Secretary's note: This input by the experts from Japan responded to an initial draft request for comments sent to the FRAV stakeholders on 8 June 2020. The initial draft raised significant reservations and therefore was superseded by a revised request for comments (FRAV-03-05-Add. 5). At the request of the experts from Japan, this response is reproduced for the 4th FRAV session.

System Safety: Opening Discussion

Accident Rate Caused by Human Factors of Driver (Highway) ●

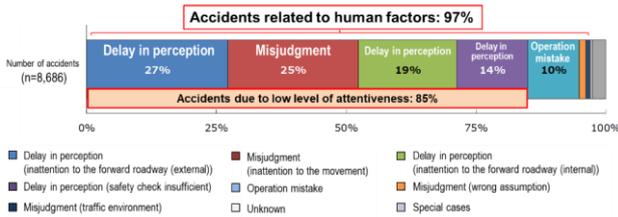
In reality the most of accidents are caused by human factor such as distraction. Because of the free of distraction of AD system, with the AD system with better capability than competent and careful human driver, the traffic society can get the big safety benefit from AD.

- 97% of the accidents were related to the human factors of driver. (of which 60% was due to delay in perception)
- Most of the accidents can be prevented if the driver's level of attentiveness is high.

Japan proposes to change “in equal or safer performance than a human driver” to “in equal or safer performance than a **competent and careful** human driver” and “The nominal operation of the ADS shall” to “When in the automated driving mode, ADS shall” in paragraph 4.4.6..
